## 1.0 BUILDING DESCRIPTION

Department of Public Works Building  
Structural Evaluation and Code Compliance Review

Photo 6 – 6"x8" Glulam posts at west garage doors

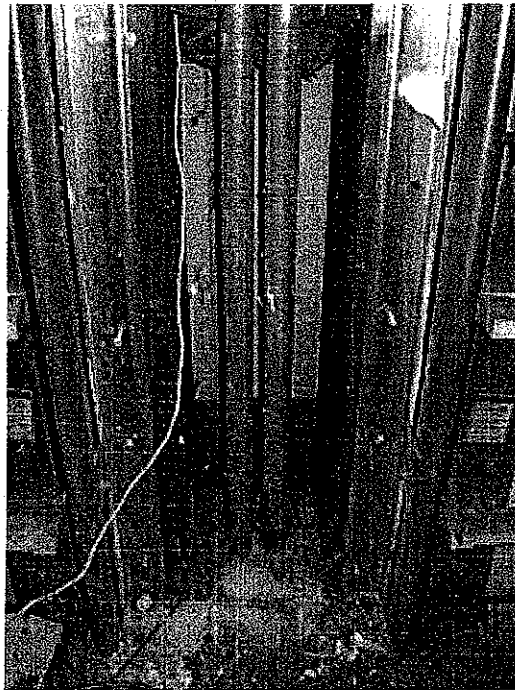
3. The typical double 2x12 LVL header around the building is adequate to support the load away from the garage doors; however, the connection to the studs is inadequate. The connections were found to be made by 16d common nails, (8) eight nails on either side (inside and outer – 16 nails total).
4. The 6X8 glulam jamb post is inadequate to support the load at the garage door openings, and the connection to the post is inadequate to transfer the

load. Again, utilizing only common nails – no lag screws or through bolts were observed during our investigations.

**Photo 7 – Exposed southwest corner of South Storage Mezzanine**

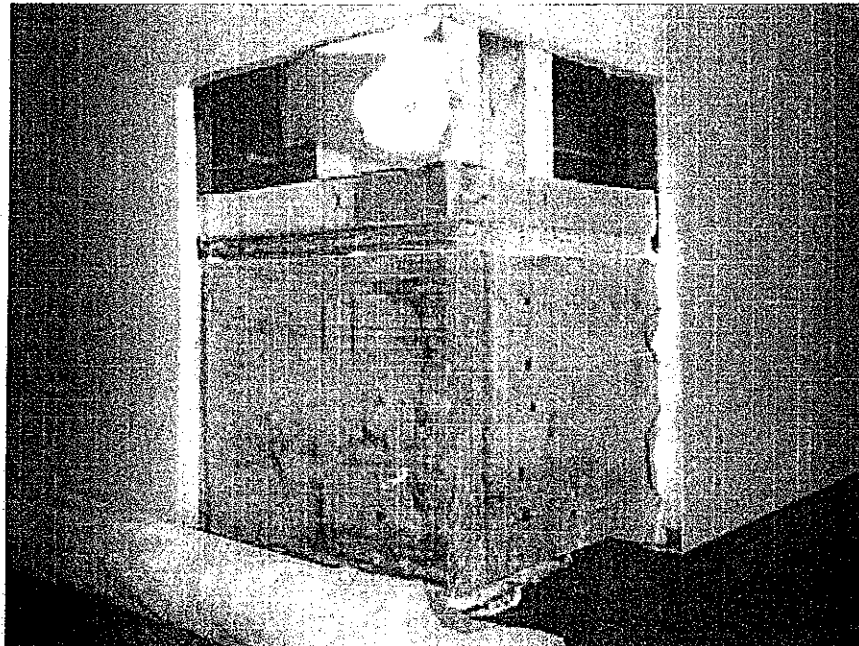
6. A portion of the framing at the west mezzanine is inadequate, including the double 2x12 headers and the stud wall supporting the cantilever section.
7. The southern mezzanine double 2"x10" header framing between the lally columns is inadequate for a storage mezzanine design load.
8. Lally columns do not have independent foundations. They bear directly on the 12" floor slab with no positive connection at their respective bases. In addition, some bear directly on the floor slab construction joints.

Photo 10 - Roof truss framing as taken from Attic facing northwest.

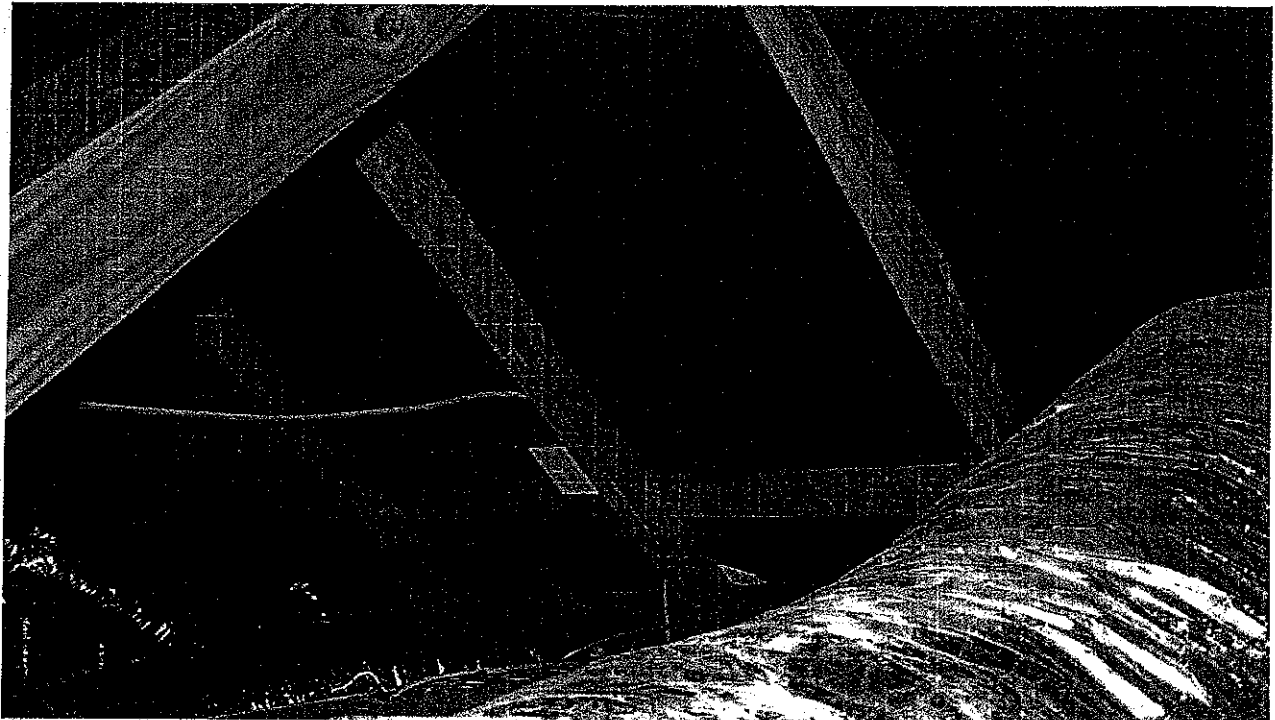
1. One line of 2"x4" bracing was found to be non-continuous during the inspection of the existing prefabricated roof trusses. This is not installed per the original truss manufacturer's specification. In addition, there are four more bracing lines needed to address the wind uplift condition on the truss.
2. A positive connection was determined to be provided from each truss to either a glulam post or 2"x8" wall stud and is sufficient to resist the uplift forces.
3. No underlying sheathing was observed below the exterior corrugated metal roofing.
